Model: NAD 30S/30/40 DF67		Date: 31-Oct98	No.: 1
Modified Article: Parts catalog correction		Prepared by: E. Fukuyama	
From: GTS and S Field Information Dept.			
Reason for Modification:	<input checked="" type="checkbox"/> Parts catalog correction	<input type="checkbox"/> Vendor change	<input type="checkbox"/> To meet standards ()
	<input type="checkbox"/> To facilitate assembly	<input type="checkbox"/> To improve reliability	
	<input type="checkbox"/> Part standardization	<input type="checkbox"/> Other

Model: NAD 30S/30/40 DF67		Date: 15-Feb-00	No.: MA680003
Modified Article: Drive Gears		Prepared by: E. Fukuyama	
From: Technical Services Dept., GTS Division			
Reason for Modification:	<input type="checkbox"/> Parts catalog correction <input type="checkbox"/> To facilitate assembly <input type="checkbox"/> Part standardization	<input type="checkbox"/> Vendor change <input checked="" type="checkbox"/> To improve reliability <input type="checkbox"/> Other	<input type="checkbox"/> To meet standards ()

Model: NAD 30S/30/40 DF67		Date: 17-Oct-00	No.: MA680007
Modified Article: Interface Harness		Prepared by: E. Fukuyama	
From: Technical Services Dept., GTS Division			
Reason for Modi

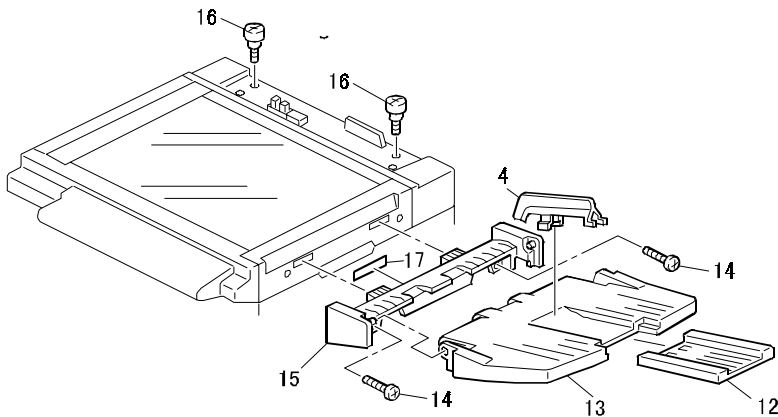
Please correct your parts catalog for DF67.

Old part number	New part number	Description	Qty	Int	Page	Index	Note
A6804321	A6804331	Exit Tray	1	-	5	13	
A6804331	A6804321	Exit Tray Holder	1	-	3	15

4.ORIGINAL TRANSFER (A680)

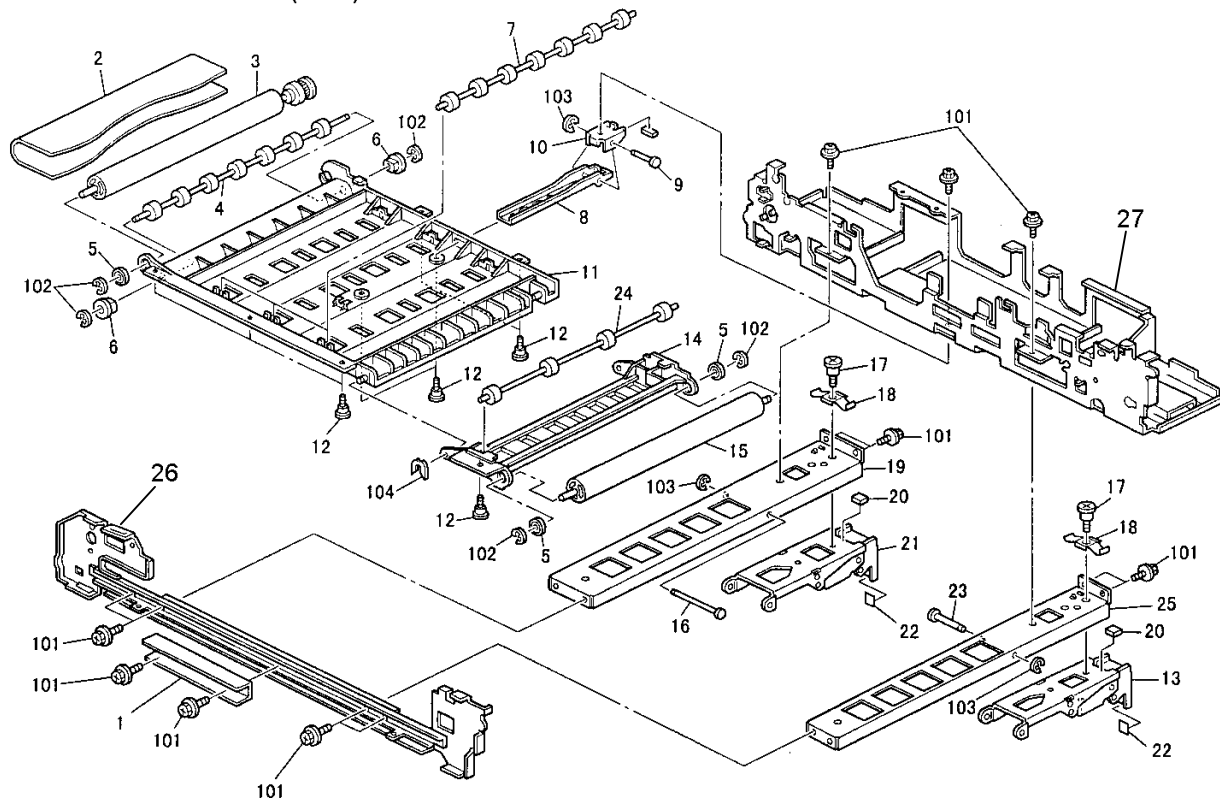
The following parst have been registered as service parts.

New part number	Description	Q'ty	Int	Page	Index
A6801111	Side Plate : Front	0-1	-	11	26
A6801121	Side Plate : Rear	0-1	-	11	27

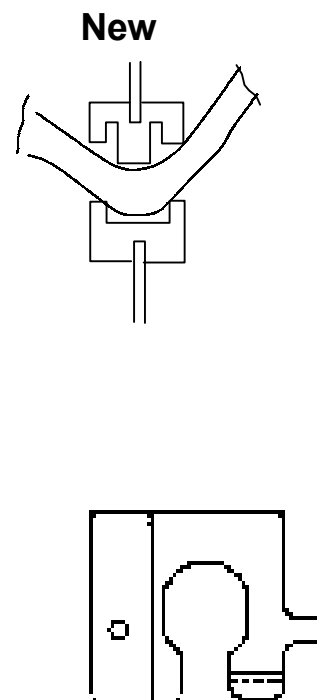
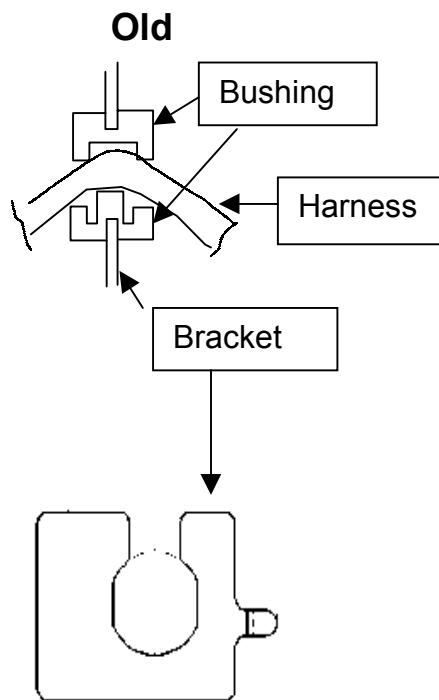
When the DF is opened to full-vertical (90 degrees), stress is applied to the harness in the area of the bushing. This eventually causes a broken connection after this action has been repeated over and over.

The shape of the bushing bracket has been changed to minimize the bending angle of the harness when the DF is opened 90 degrees.

Old part number	New Part number	Description	Q'ty	Page	Index	Note
A6805800	A6805801	Interface Harness	1-1	19	4
